Staff Report & Recommendation

Design Review Board

DRB18-0341

2324 North Bay Road

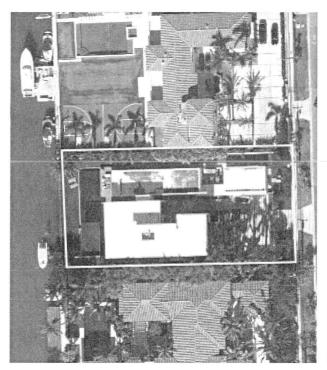
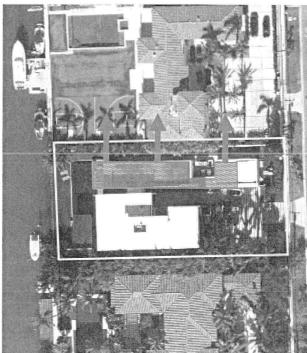
The first design waiver pertains to the second floor to first floor ratio. Since the proposed home has a lot coverage that under today's code is 34%, the volume of the second floor is limited to 70% of the first floor, unless a waiver is approved by the DRB. While this section of the City's single family regulations was not adopted at the time of the original construction, for analysis purposes, the second floor currently is configured to the first floor by 60%. With the addition of a 2,127 SF second floor addition to the one-story portion of the residence, this ratio increases to 97%. Staff believes that the greater 2<sup>nd</sup> to 1<sup>st</sup> floor ratio request proposed is commensurate with the style and design of the home and will not be visible from the right-of-way since the addition will be obscured by the existing two-story residence. Further, the additional bedrooms will be less impactful to the neighboring property to the north since it will replace an existing outdoor flat roof area that could

potentially be used as a recreational sundeck. Staff does recommend eliminating the balcony/walkway that projects and extends into the required side setback at the second level as it may impact the privacy of the abutting property. With this modification, staff is supportive of this requested waiver.

- c. The (north) side open space requirement **shall** be waived as proposed.
  - d. The proposed balcony/walkway at the second level within the (north) side yard shall be eliminated.
